**DATE:** February 8, 1973

**TO:** BRIDGE DESIGN PERSONNEL  
**FROM:** Frank Harrison, Assistant Bridge Engineer  
**SUBJECT:** Changes in Articles 1.7.5 and 1.7.88 of the AASHO Design Specifications

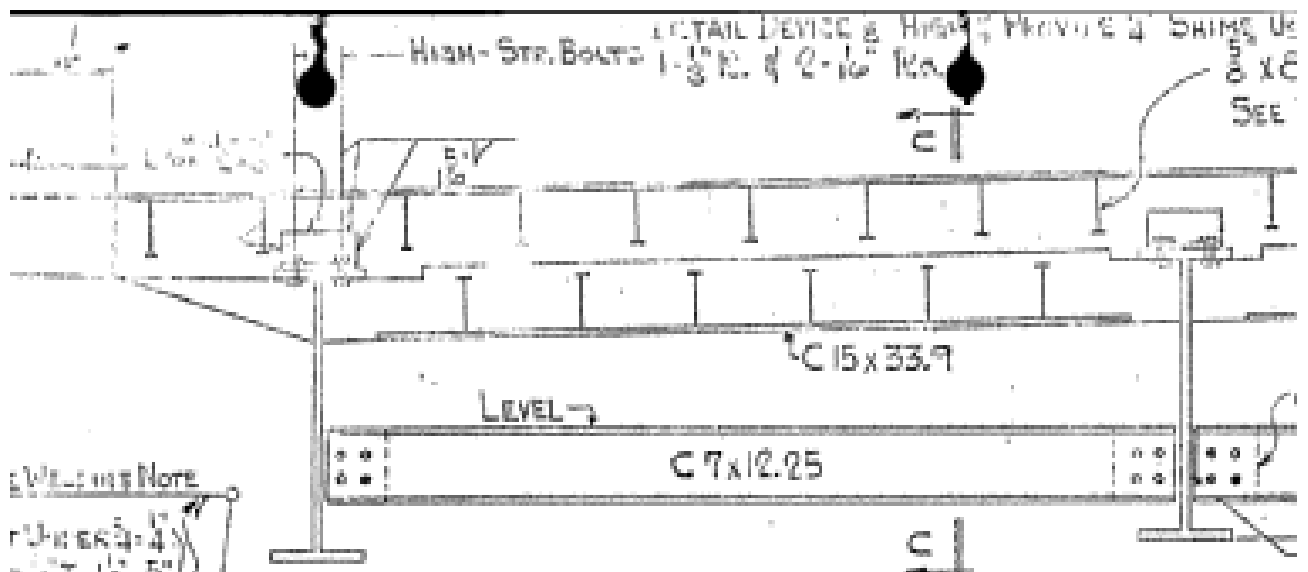
Our Office Policy will be to allow subparagraph (1) on secondary members only (struts, cross frames, gusset plates, expansion devices, etc.) of a standard design and to cover by a note on the plans. Subparagraph (3) shall not apply to this condition. For custom design of secondary members, the designer shall determine whether to apply subparagraph (3) with subparagraph (1). *See Example for simple steel spans*

Article 1.7.88 - Change the last paragraph to read as follows:

The diameter of the hole shall be taken as  $1/8$ " greater than the nominal diameter of the rivet or high strength bolt unless larger holes are permitted in accordance with Article 1.7.5.

Our Office Policy will be to apply the revision of Article 1.7.88 on jobs on which structural steel design is started after the date of this memorandum, and as stated for Article 1.7.5 above to be covered by notes on the plans.
